Access Compliance Report Public Rights-of-Way (Curb Ramps)

Main Street: ANNIVERSARY_LN Cross Street: IRVINE_AVE Location: SE

ADA ID: RPRK211018122450 Ramp Type: Type 7 - Directional 2 Initial Pass/Fail: Pass Overall Compliance: No Severity Score: 4

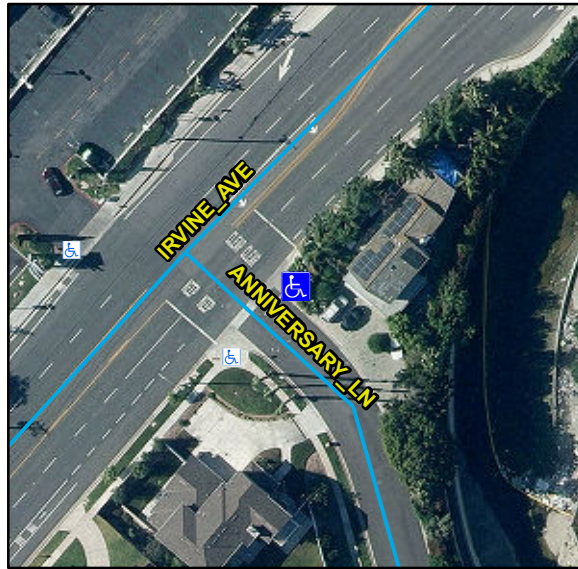
Compliance	Description	Data	Compliance	Description	Data
N/A	Ramp Length (in)	152	N/A	Flare Type LT	
Yes	Ramp Width (in)	70			None
Yes	Ramp Run Slope (%)	6.6	N/A	Flare Slope LT (%)	N/A
Yes	Ramp Cross Slope (%)	0.9	N/A	Flare Traversable LT	N/A
Yes	Grade Break	Yes	Yes	Flare Type RT	
Yes	Grade Break Slope (%)	4.6			Curbed2
Yes	Grade Break Cross Slope (%)	1.2	N/A	Flare Slope RT (%)	N/A
	Addl Para Ramp Left?	No	N/A	Flare Traversable RT	N/A
	Addl Para Ramp Right?	No	Yes	DWS Provided	Yes
N/A	Landing Present	Yes	Yes	DWS Contrast	Yes
No	Landing Length (in)	39	Yes	DWS Length (in)	36
Yes	Landing Width (in)	79	Yes	DWS Full Width	Yes
Yes	Landing Run Slope (%)	1.4		DWS Offset Type	Multiple
No	Landing Cross Slope (%)	2.1	Yes	DWS Left Offset (in)	0
N/A	Landing Movement Obstructed?	No	No	DWS Right Offset (in)	70
	Landing Movement Type	N/A			
N/A	Landing Shared	No			
N/A	Marked Crosswalk 1	No	N/A	Clear Space	N/A
	Crossing 1 Direction	SW	N/A	Clear Space To Crosswalk (in)	N/A

Marked Crosswalk 1 Width (in)	N/A			
N/A	Ramp Inside Crosswalk 1	N/A			
	Crossing 1 Slope (%)	8.4			
	Crossing 1 Cross Slope (%)	4.2			
Yes	Gutter Ponding	No	No	Curb Slope	54
Yes	Gutter Lip Height (in)	0		Road Run Slope (%)	N/A
Yes	Gutter Run Slope (%)	5		Road Cross Slope (%)	N/A
No	Gutter Cross Slope (%)	5.3		Parallel Ramp Side	Right
Yes	Overall Surface Condition	Acceptable	No	Perp Joint Present	No
	Cross Gutter Present?	Yes		Spandrel Present?	Yes
	Replace Cross Gutter?	No		Replace Spandrel?	No

Remove & Replace Entire Ramp. Remove & Replace Gutter.
